Our ref: DA305-7-2003-PA-89

Subject: Wambo Coal Mine – Approval of Extraction Plan Variation for Longwalls 24 to 26

Department’s consideration of the revised Longwall 24 to 26 Extraction Plan

Table 2 | Department’s Review Comments for Wambo Extraction Plan - Longwalls 24 to 26 (revision D, dated November 2024)

Figure 2 | Proposed Variation to the Longwall 24 to 26 Extraction Plan Area

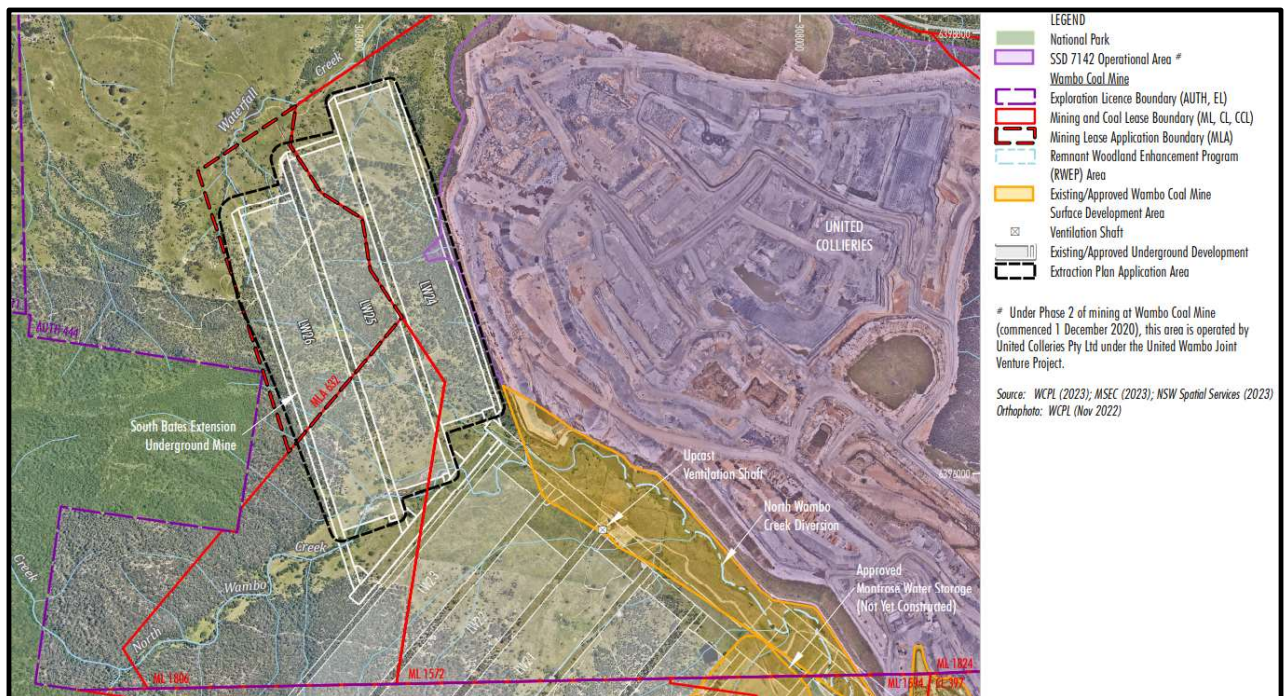
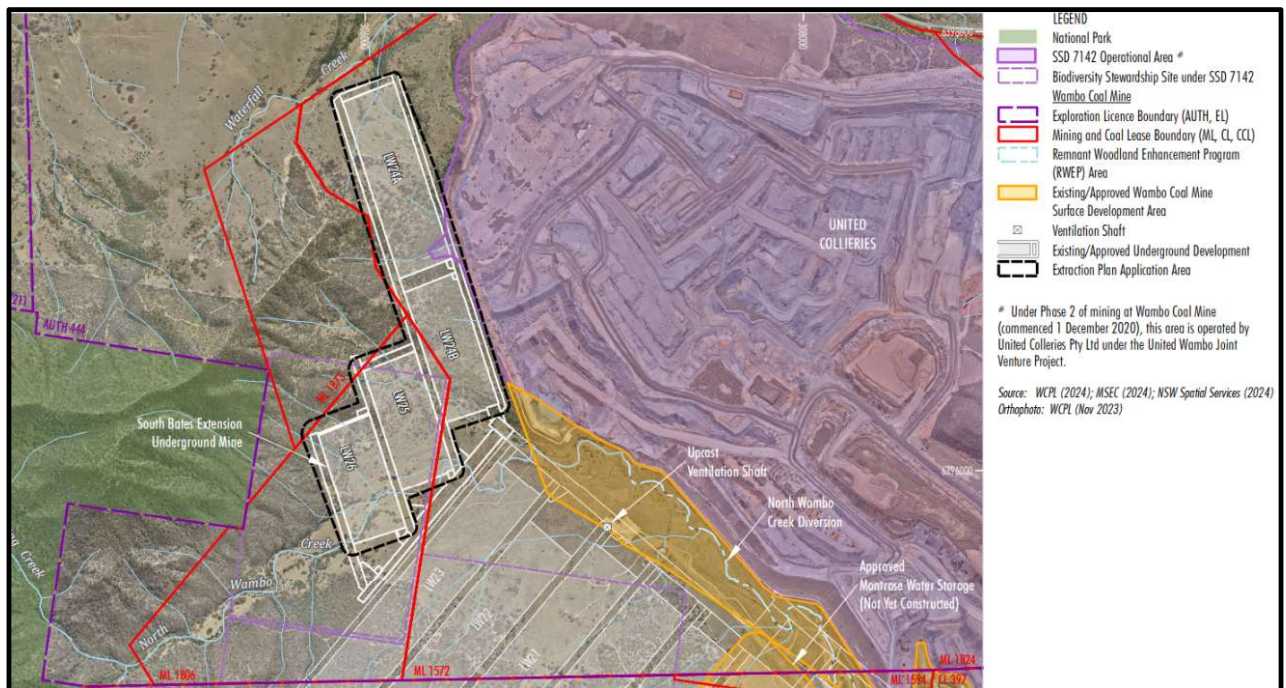
Since modification 19 was approved, there has been a minor amendment to the length of Longwall 24 (been reduced by approximately 39 meters at the southern end). The revised mine plan is shown in **Figure 1** below. These changes were incorporated into the Extraction Plan for Longwalls 24 to 26 (revision C, dated November 2023). This Extraction Plan was approved on 6 December 2023.

Since that time, WCPL has identified adverse geological conditions in the Longwall 24 to 26 mining area which will hinder the full development and extraction of the longwall panels. To avoid these conditions, WCPL is proposing to modify (shorten) the layout of the Longwall 24 to 26 mine plan.

Since the approval of the Longwall 24 to 26 Extraction Plan in December 2023, WCPL is proposing to modify (shorten) the layout of the Longwall 24 to 26 mine plan to avoid adverse geological conditions which will hinder the full development and extraction of the longwall panels. The following changes are proposed:

- dividing Longwall 24 into two longwall blocks (Longwall 24a and Longwall 24b), separated in the mid-section of the panel by approximately 63m;
- shortening the overall length of Longwall 25 by approximately 1,010 meters at the northern end and extending the southern finishing end of Longwall 25 by 15 meters; and
- shortening the overall length of Longwall 26 by approximately 1,047 meters at the northern end and extending the southern finishing end of Longwall 26 by 81 meters.

While the maximum predicted subsidence effects have not changed, the total surface area affected by mine subsidence has been reduced by 62 hectares (ha) (from 135 ha to 74 ha).

The maximum subsidence effects are predicted to occur above the eastern parts of Longwalls 24 to 26, where the depths of cover are the shallowest (less than 100 m). Although the layout of Longwalls 24, 25 and 26 has changed from when modification 19 was approved, the Department acknowledges that there are no changes to the maximum predicted subsidence effects, including vertical subsidence and tilt.
